**TO: ALL VOLVO RETAILERS - US AND CANADA**  
**RE: RECALL CAMPAIGN 141: INSPECT/REPLACE ENGINE COOLING FAN CONTROL**  
**MODULE (EFCM) AND COOLING FAN ASSEMBLY**

| <b>VOLVO</b>  |                            |                           |                                   | <b>TITLE:</b><br>Recall Campaign 141:<br>Inspect/Replace<br>Engine Cooling Fan<br>Control Module<br>(EFCM) and Cooling<br>Fan Assembly<br>MY 99-01 S80, MY 01<br>S60, V70, V70XC |  | <b>GROUP:</b><br>26                           | <b>NO:</b><br>141 |

NO: 26 - 07  
DATE: 11/11/2004  
MODEL/YEAR: 1999 - 2001 S80 / 2001 S60, V70 & V70XC  
CHASSIS: (NOTE: RETAILERS MUST CONFIRM VEHICLE ELIGIBILITY)  
SUBJECT: Recall Campaign 141: Inspect/Replace Engine Cooling Fan Control Module (EFCM) and Cooling Fan Assembly.  
REFERENCE: SMB 26-141 / PB 26-141

A2600498

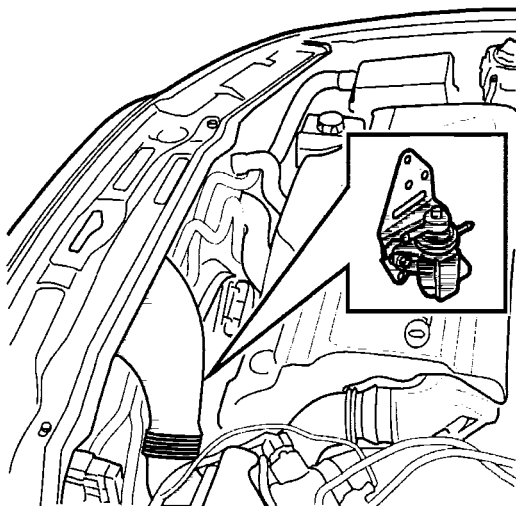
If the cover on the Engine Cooling Fan Control Module (EFCM) is black plastic then the EFCM and Fan Assembly must be replaced, proceed to page two.

If the cover is metal then the EFCM and Fan Assembly has already been replaced and no further action is required.

The EFCM and Fan Assembly can also be identified via the part number on the decal (A) located on the fan shroud.

Fans with the following part number are OK and must not be replaced:

| 8649634  | 30723053 |
| 30647253 | 30645148 |
| 30636581 | 30636445 |
| 30680547 | 30680512 |

D2800683

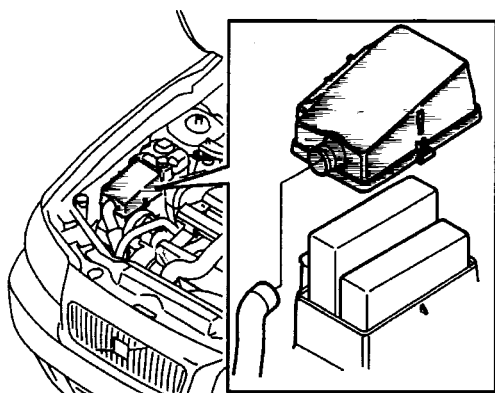
**Note: On cars manufactured between week 9950 and 0048 (for chassis. #, see affected vehicles list under the Material list):**

**Replace the cover on the cold box (Transmission Control Module (TCM), Engine Control Module (ECM)).**
